Urgent Field Safety Notice

Birdie & Flamingo Lifters

Invacare Ref: FSN 044

Urgent Safety Information:

**New Assembly of
Steel Carabiner**

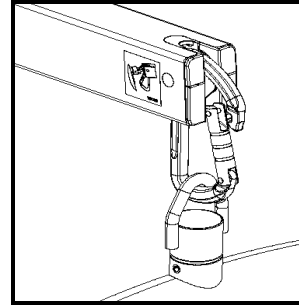
Further preventive action was planned to reduce the probability of spreader bar disengagement. We will **Replace / Refit Steel Carabiner, assembled upside down**.

Due to a small change of carabiner's shape, it was also necessary to modify the plastic moulded part where the carabiner is fixed.

- Change the carabiner for the steel one (1449515) and assemble it, upside down
- Change plastic part (1509328)
- Change Labels (1511759 or 1511760 or 1514578 or 1522220 or 1528280), according Birdie model and correspondent Work Instruction (see attached List)
- Place a new label on the Mast (1180355)

- Remove the Carabiner in Steel and Refit assembling it upside down
- Change Labels (1511759 or 1511760 or 1514578 or 1522220 or 1528280), according Birdie model and correspondent Work Instruction (see attached List)
- Place a new label on the Mast (1180355)

**Carabiner in Steel
(1449515)**

**Plastic part
(1509328)**

**New Label
(1180355)**
